BOARD OF ADJUSTMENT MEETING CITY OF ST. PETE BEACH

Wednesday, June 28, 2023
2:00 PM

CITY OF ST. PETE BEACH
DRAFT BOARD OF ADJUSTMENT MEETING MINUTES
May 31, 2023 2:00 P.M.

Figure 3: Existing Survey (N.T.S.)

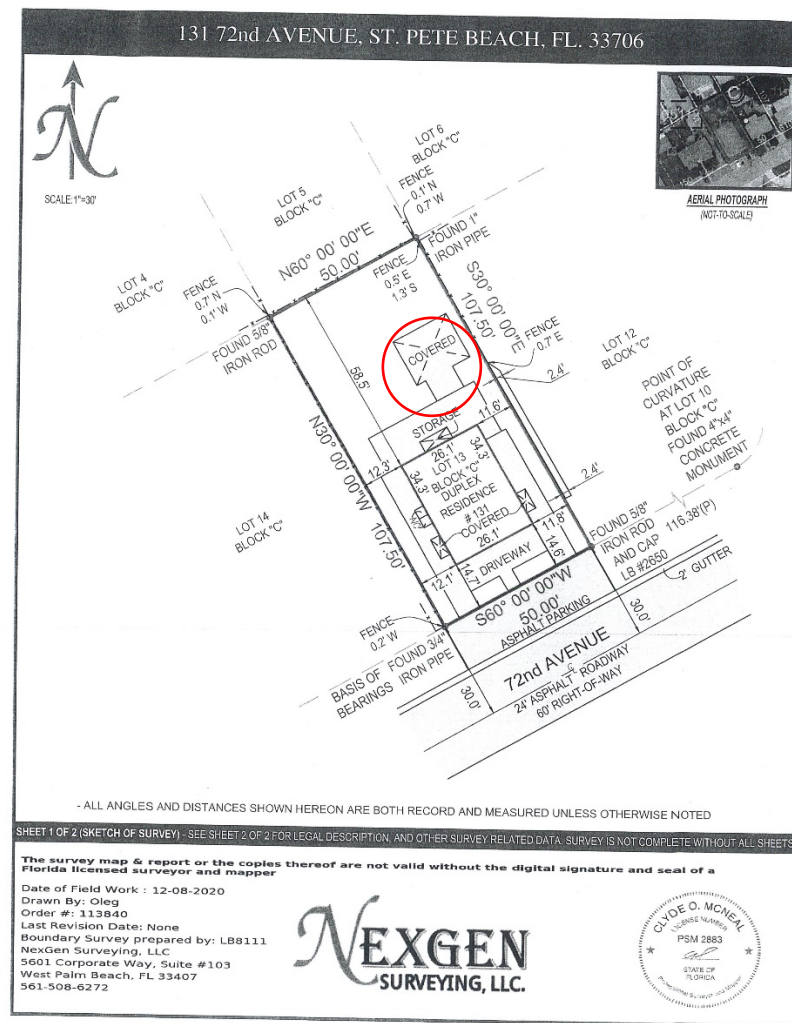
1. Variance required:
 - a. **Patio Covers, minimum side yard setback required:** where existing structure does not meet the required 5' side yard setback with 3' provided, an encroachment of 2' into the setback.

- *While the structure does meet the side yard setback requirement, it was not granted any permits and was constructed 3' closer to the property line than permitted. It should be noted that a 6' high fence currently exists, providing shielding of the structure.*
- 8. The requested variance is in harmony with the general intent and purpose of the comprehensive plan and the Land Development Code, is not injurious to the neighborhood or otherwise detrimental to the public safety and welfare, is compatible with the neighborhood, and will not substantially diminish or impair property values within the neighborhood.
 - *The LDC allows for a covered patio structure which is recognized as a permitted accessory structure. The current structure does appear to meet all zoning requirements other than the minimum side yard setback.*

- If the Board does not grant the variance, the applicant should provide testimony of how the structure would be brought into conformance or if intended to be demolished.
- The applicant should discuss if a contractor has been contacted to assess the construction and if it was built to code.
- The applicant should provide testimony if adequate landscaping exists that screens the structure from the street and if any additional landscaping is planned to be installed in the side yard where the structure is located.
